## British Gliding Association Aircraft Inspection

| Number:<br>010/12/2000 | Issue:<br>1 |

Subject: ASK 13 and ASK 18 Elevator Engagement

Applicability: Schleicher ASK 13 and ASK 18

Possible sources of mistakes in the automatically elevator connection  
of the types Schleicher Ka 2 and Ka 2B, Ka 6, K 7 and K 8. ( US 7G1, 7G3, 7G4 )  
This point should be given special attent at the inspections.

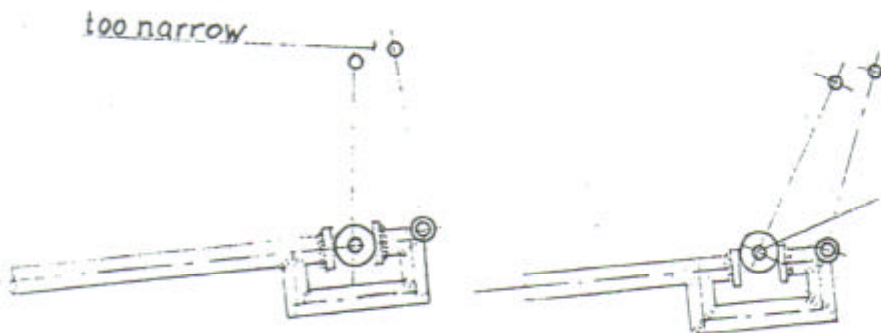
1. Correct make:

Must be in center.  
or ballbearing  
some what lower

$$a_1 = a_2$$

$$b_1 = b_2$$

b2 may be wider until  
4 mm, in no case  
smaller. Check it with  
a pair of compasses.  
Therefore disassemble  
one half of elevator.

2. Ball bearing too high.

3. Parallelogram gearing not correct:

too narrow

goes out at deflection  
"push".

The inverse case can be, but is not so serious.

4. The stop of the elevator control must be at the seat. When the control  
is stopped at the rear, the push rod may be cracked by the very high  
hand power.

A new bearing support  
"B" is to be made with  
adjusted measures if  
the above dimensions  
are not correct.
